SUBJECT : HYUNDAI IT CORP.
FCC ID : PJILT42DW000

Transmitted herewith, on behalf of HYUNDAI IT CORP. is an application for a Class II Permissive Change Certification of the following LCD TV

FCC ID : PJILT42DW000
TYPE : LT42DW000

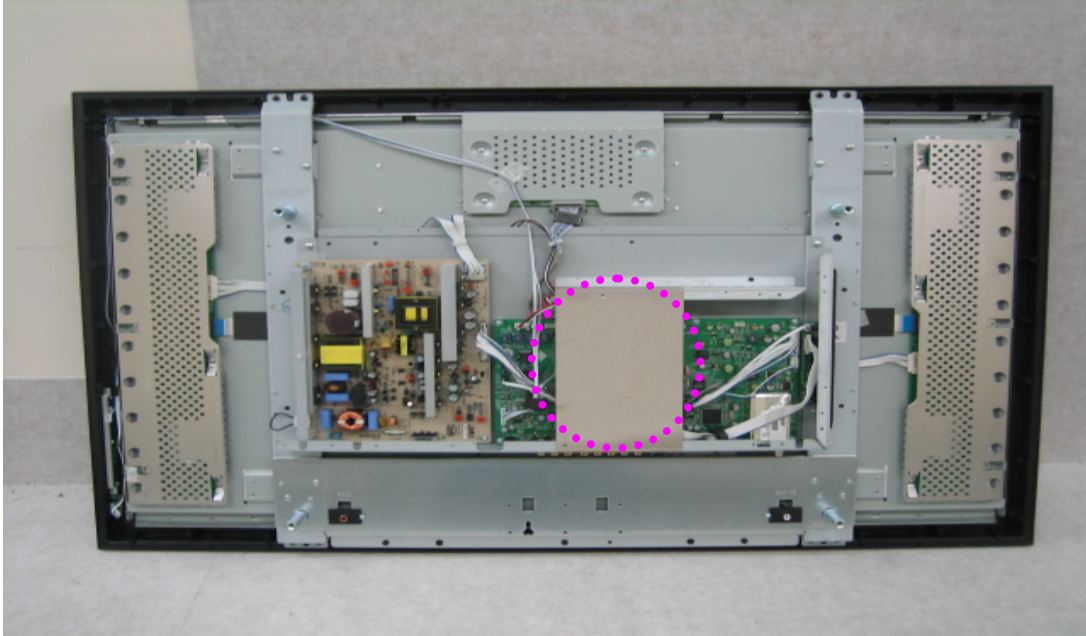
1. Attached the Shield tape
2. Attached the Core

Attached the Shield tape

Attached the Core
